2_55 Locating Existing EOP

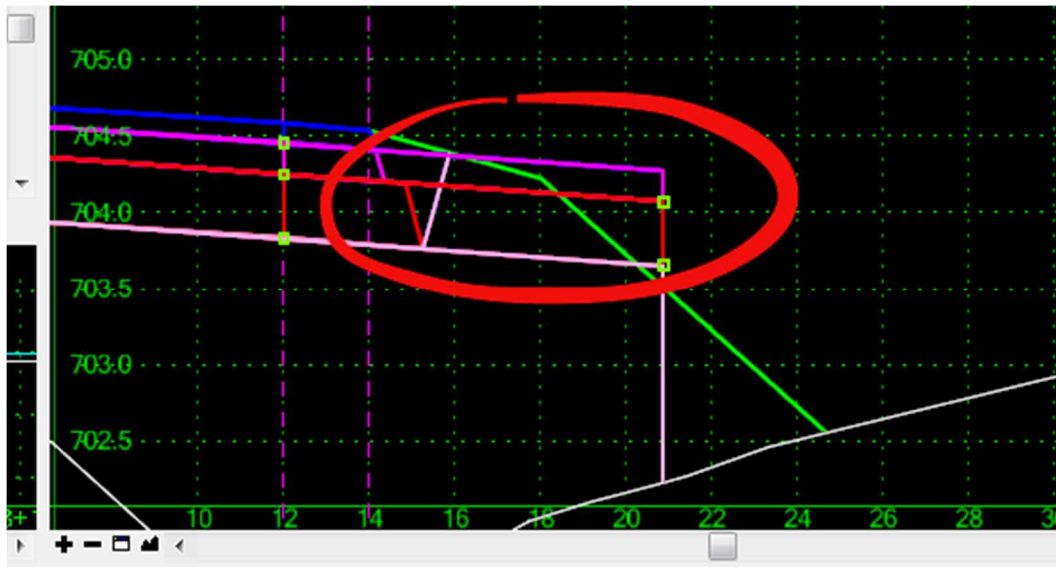
When I entered my pavement information for this area I entered an IEOP and an OOEP. This seems to be confusing the template in some areas, as it is widening pavement beyond the paved shoulder.

The reason why the inside pavement is extending past the outside paved shoulders is because you are showing the template the existing edge of pavement where pavement wedging does not occur.

Delete the existing edge of pavement lines when you cannot wedge so the template will display a new pavement section.
